April 24, 1997

Reference: Trail Ridge Landfill
Renewal of FDEP Permit No. SC16-18444
FDEP File Numbers 296641 and 296642
ET&M No. E96-49-1C

We have received your second Request for Additional Information (RAI) dated March 28, 1997 regarding the referenced project. The following is our response to your RAI request.

SITE PLAN

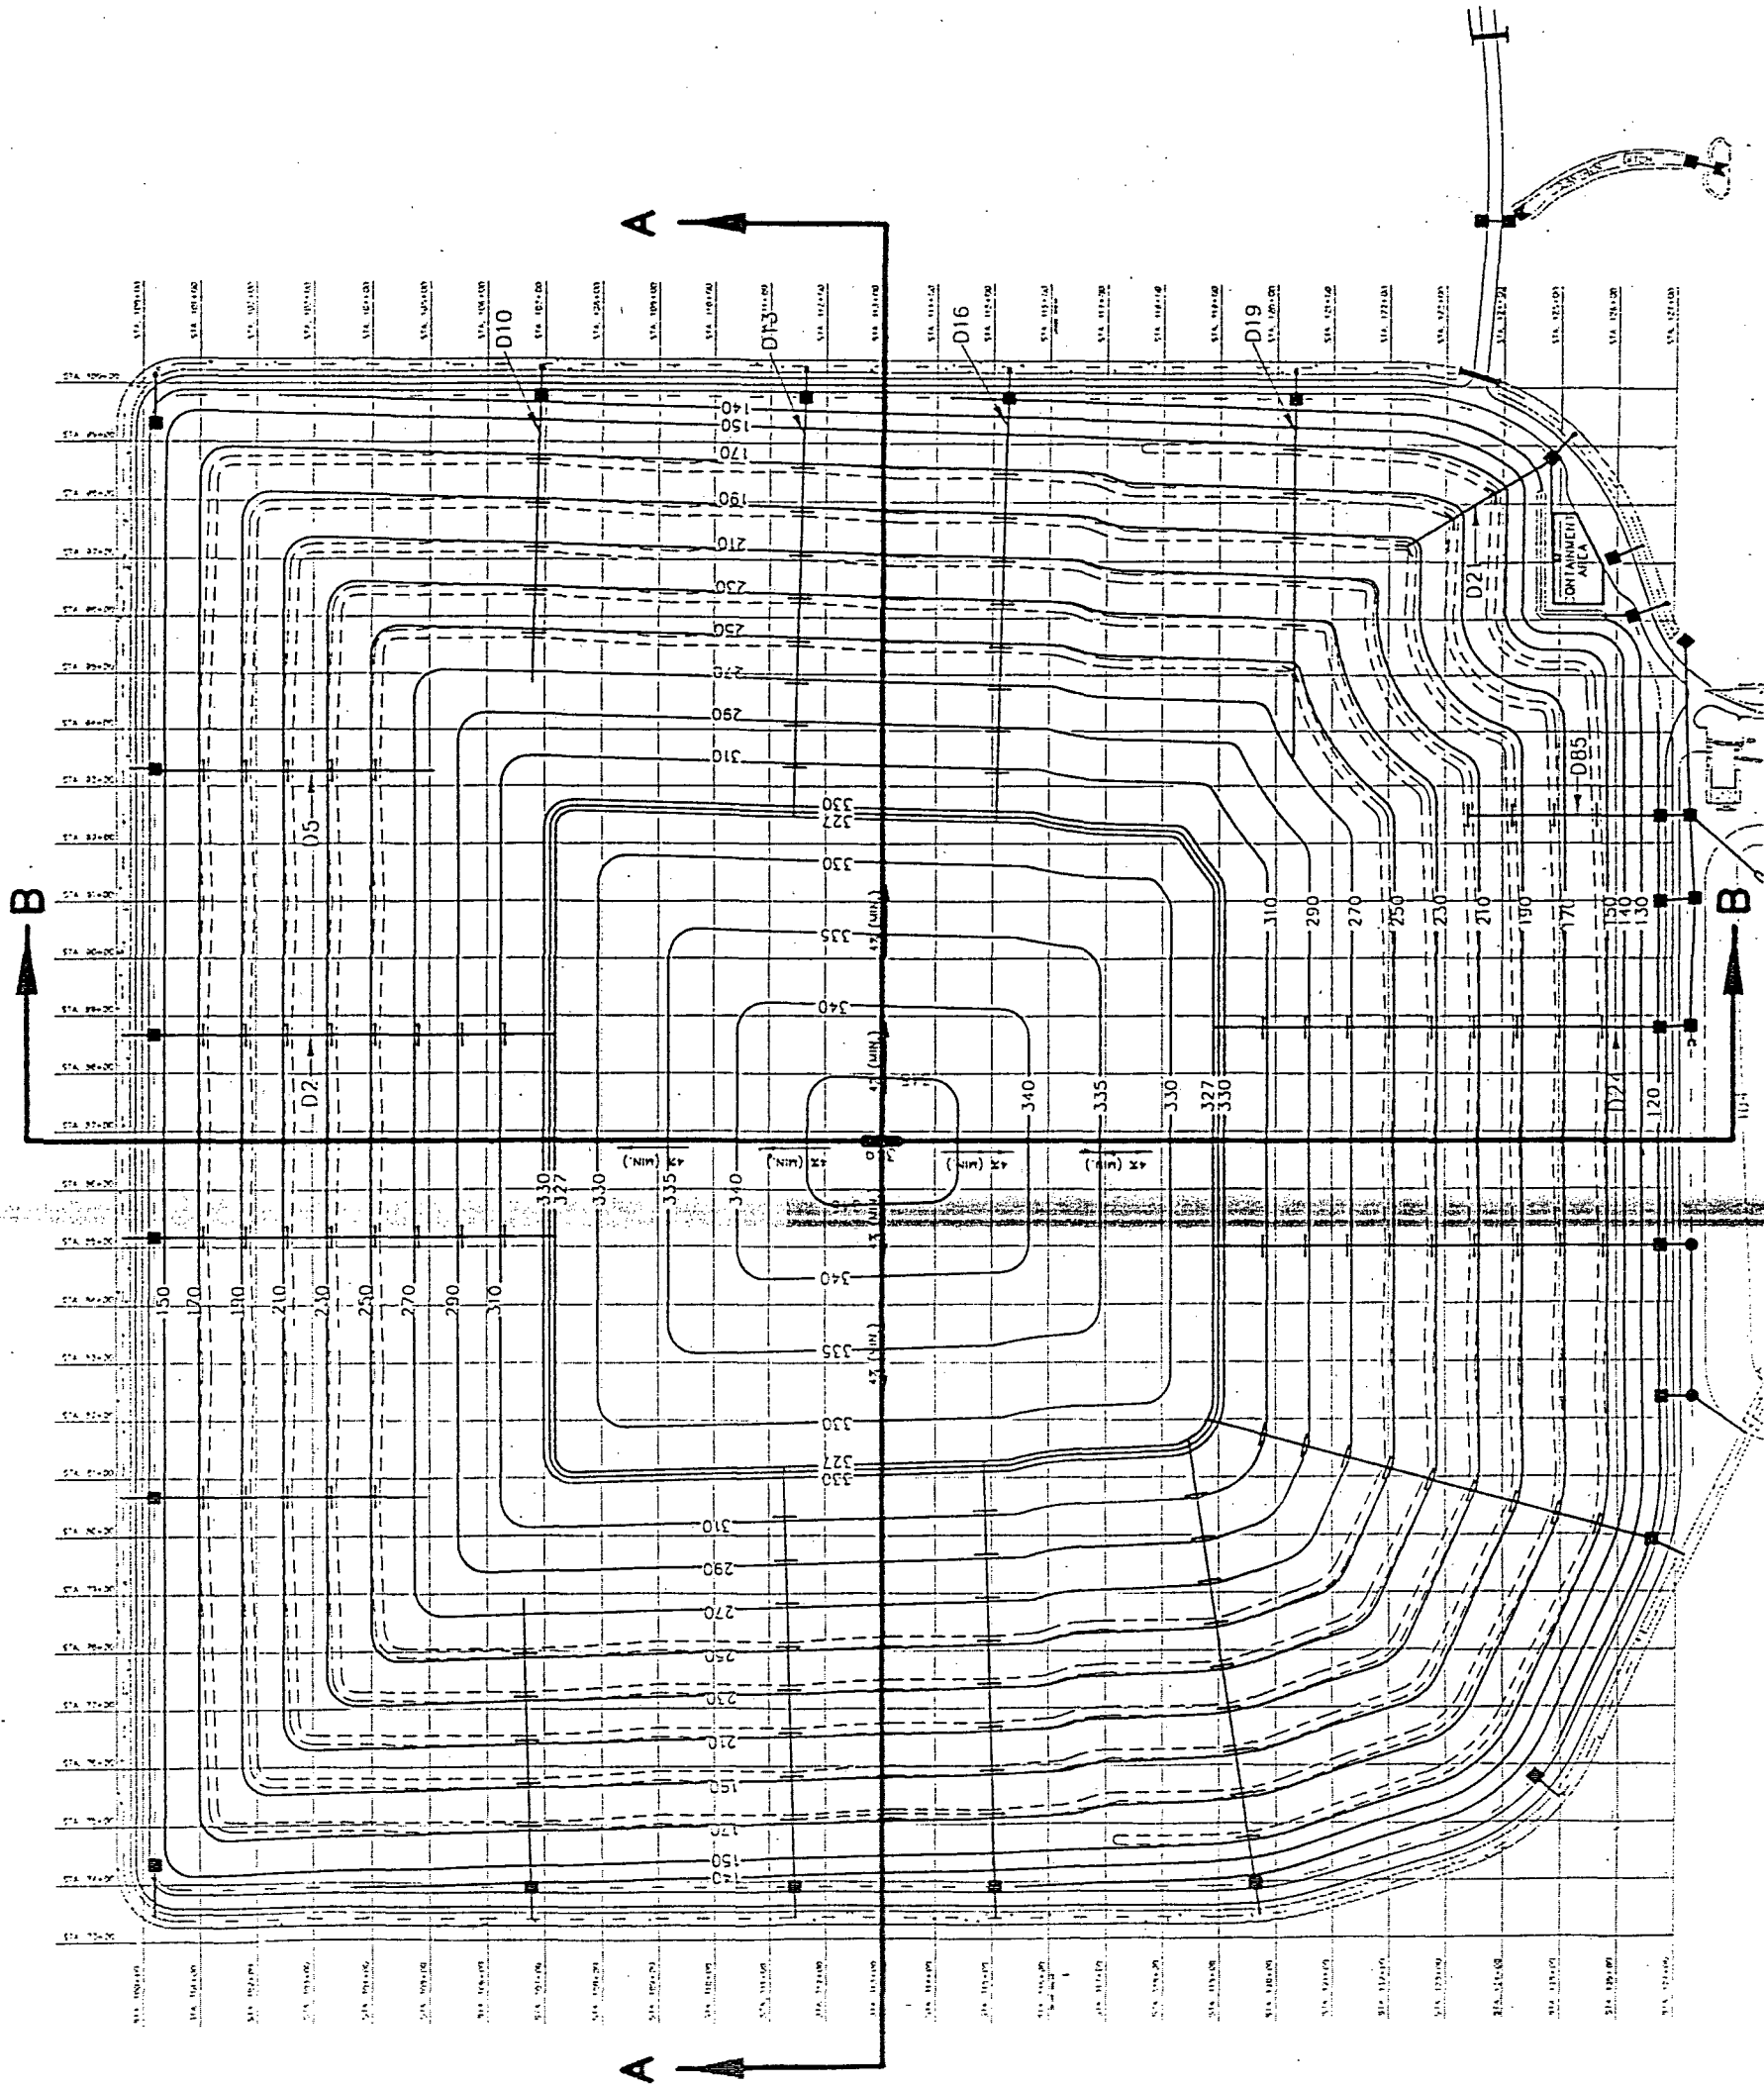
4. The station numbers on the Site Plan prepared by LAW Engineering is not clear. Please resubmit the site plan which clearly shows the stations to help review the tabulated data for settlements. A drawing with a scale of 1 inch is to 200 feet is preferred if available.

The Site Plan has been revised as requested and is contained in Attachment C. Further, please note that these cross-sections are shown on Drawing Nos. 9 and 10 on a horizontal scale of 1 inch = 200 feet.

ATTACHMENT F

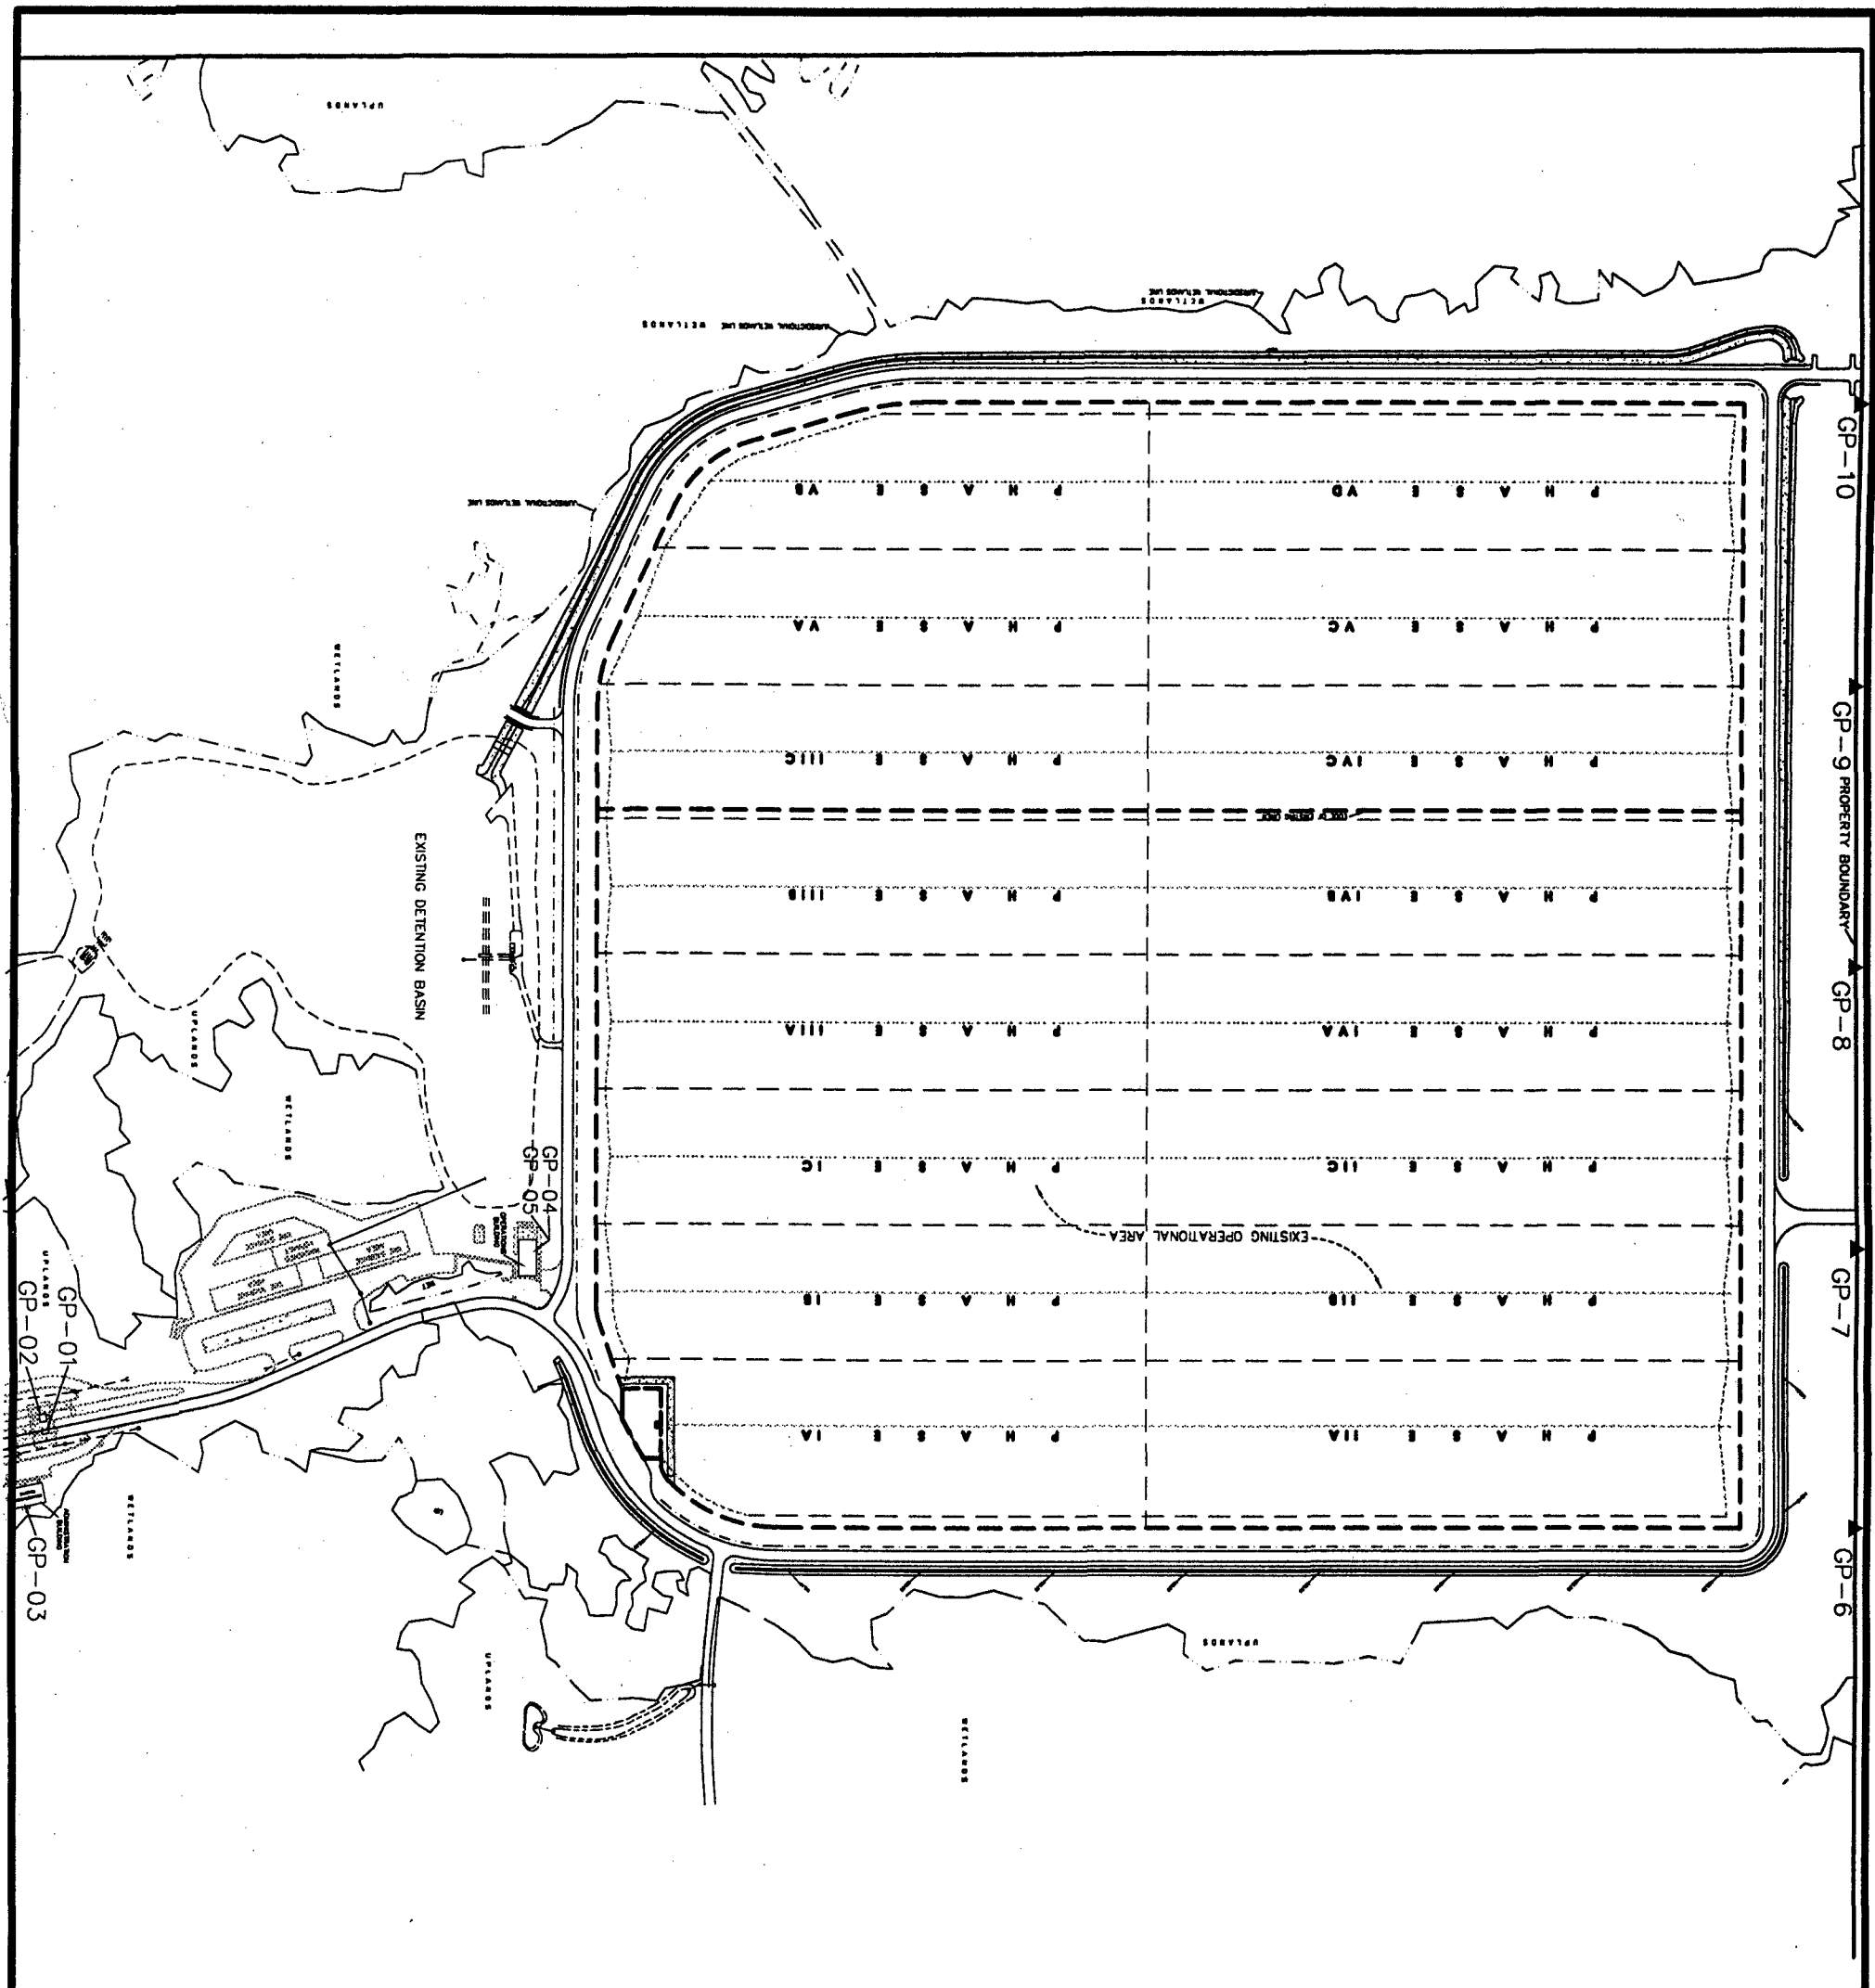
Comment 15. *Please justify not proposing to install gas monitoring probes along the southern property boundary.*

15. Appendix H, Gas Monitoring Plan, please note that all gas monitoring probes will be considered compliance points.

According to FAC Rule 62-701.400 (10)(a), landfill gas control systems shall be designed to prevent the concentration of methane and other gasses generated by the landfill from exceeding the lower explosive limit for gasses at or beyond the landfill property boundary. The southern property boundary is approximately 700 feet from the landfill limits and there is a wetlands between the landfill and the property boundary. In the remote circumstances where gas is found outside the lined area, we do not anticipate that methane or other gases could potentially migrate beyond the southern property boundary.

According to Rule 62-701.400 (10)(a), F.A.C., landfill gas control systems shall be designed to prevent the concentration of methane and other gasses generated by the landfill from exceeding the lower explosive limit for gasses at or beyond the landfill property boundary. Therefore, if the gas monitoring probes will be considered compliance points, the probes will be moved to the property boundary. Please see the revised Gas Probe Plan as contained in Attachment F.
